APPLICATION NO.	FILING DATE	FIRST NAMED INVENTOR	ATTORNEY DOCKET NO.	CONFIRMATION NO.
10/659,666	09/10/2003	A. John McDonald	HE0161-A	3727
21495	7590	03/17/2004	EXAMINER	
CORNING CABLE SYSTEMS LLC P O BOX 489 HICKORY, NC 28603			WONG, ERIC K	
			ART UNIT	PAPER NUMBER
			2874	
DATE MAILED: 03/17/2004

Office Action Summary	Application No. 10/659,666	Applicant(s) MCDONALD ET AL.	
	Examiner Eric Wong	Art Unit 2874

DETAILED ACTION

FIG. 6

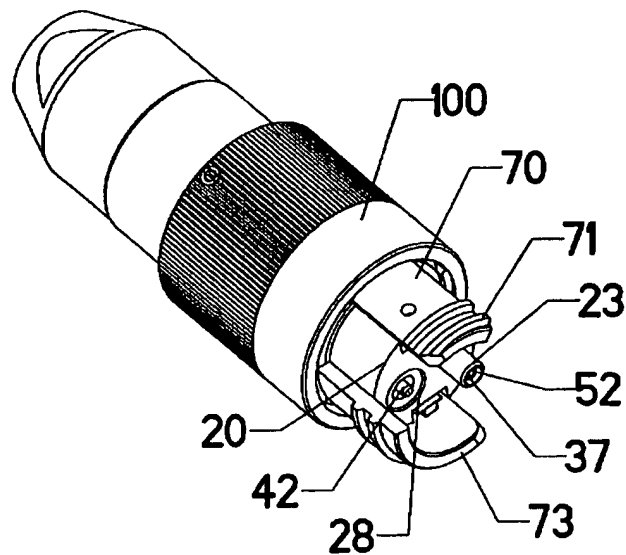
- A plug body having a shroud proximate one end thereof, the shroud defining at least one opening (Figure 6);
- A fiber optic connector disposed within the plug body and comprising a connector housing and a plug ferrule at least partially disposed within the plug body and comprising a connector housing and a plug ferrule at least partially disposed within the connector housing (Figure 6); and
- A fiber optic receptacle for mating with the fiber optic plug, the fiber optic receptacle comprising:
 - A receptacle housing defining an internal cavity opening through opposed ends (Figure 15);
 - An adapter sleeve disposed within the internal cavity defined by the receptacle housing, the adapter sleeve defining a lengthwise extending passage for the receiving portion of the plug ferrule of the fiber optic plug (250),

As to claim 26, a plug body extending lengthwise between a first end and a second end, the first end opposed from the second end, and having a shroud proximate the first end thereof, the shroud defining a pair of openings on opposite sides (Figure 6) thereof, the openings extending lengthwise from at least a medial portion of the shroud to the first end of the plug body.

As to claim 27, the pair of openings defined by the shroud are aligned with one another (Figure 6).

FIG. 15

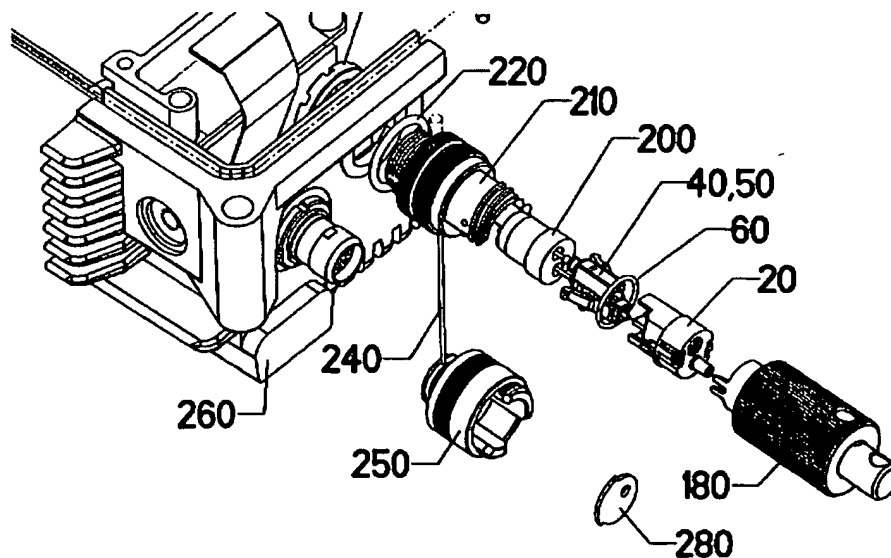
5. Claims 24, 26 and 27 are rejected under 35 U.S.C. 102(e) as being anticipated by United States Patent Number 6,234,683 to Waldron et al.

Waldron et al. discloses in figure 15, a fiber optic plug and receptacle assembly comprising:

- Wherein the shroud and the adapter sleeve are sized such that portions of the adapter sleeve are disposed within the at least one opening defined by the shroud once the plug ferrule of the fiber optic plug is inserted into the adapter sleeve.
